Docket Item # 3 BAR CASE #2009-0009

BAR Meeting February 18, 2009

ISSUE: Alterations

LOCATION: 1332 Michigan Avenue

Figure 1: Photograph of Existing Rear Façade

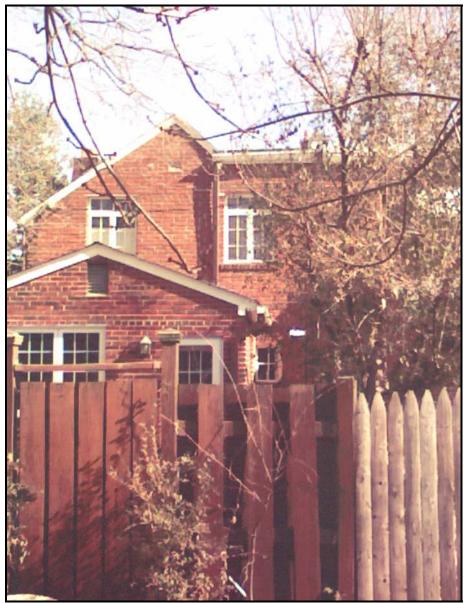
The applicant is requesting approval to replace and enlarge a single window on the first floor of the home facing a rear alley. The existing window is a wood, single-glazed, four pained, true divided, casement window which currently measures 18" x 26". The applicant is requesting approval for replacement with a Marvin Clad Ultimate Replacement Casement double-glazed, window with 5/8" muntins. The proposed window will be simulated divided light with an interior spacer bar and measure 18" x 39", increasing the height by a total of 13" or 1.6 square feet. To compensate for the increase in height the proposed window will have a light configuration of six rather than four.

The Design Guidelines recommend that: "...replacement windows should be appropriate to the historic period of the architectural style of the building". The Guidelines state that single-glazed, true divided light windows with interior storm sash are the preferred replacement window type. The Guidelines continue by saying other acceptable window types are "double-glazed true divided light wood windows...." In this particular case, given the age of the townhouse, and that the applicant intends to maintain the character defining feature of a casement window, Staff does not object to the installation of a double-insulated window, with simulated divided lights, and interior spacer bars. The Board has considered the replacement of metal casement windows in several other instances in the district and even more specifically Michigan Avenue. The window proposed in this application is comparable to the ones approved by the board for replacement at 1322 Michigan Avenue in 2006 (BAR 2006-0171) and at 1308 Michigan Avenue in 2004 (BAR 2004-0106). In the 1308 Michigan Avenue case (BAR 2006-0171) The Board agreed with Staff and approved Marvin aluminum clad wood casement windows with simulated divided lights, as stated in the report, "Staff does believe that simulated divided light windows are necessary to more accurately replicate the three-dimensional appearance of the original windows." Furthermore in the report written for the 1322 Michigan Avenue BAR case (BAR 2006-0171) staff indicates that, "In a number of other instances the Board has indicated a strong preference for aluminum clad casement windows as a replacement for metal casement windows." Additionally, due to the fact that the proposed window at 1332 Michigan Avenue is only minimally visible from a small public park across the rear alley, staff does not find the proposed

replacement window to be inappropriate and recommends approval of the application as submitted.

IV. <u>STAFF RECOMMENDATION</u>: Staff recommends approval of the application as submitted.
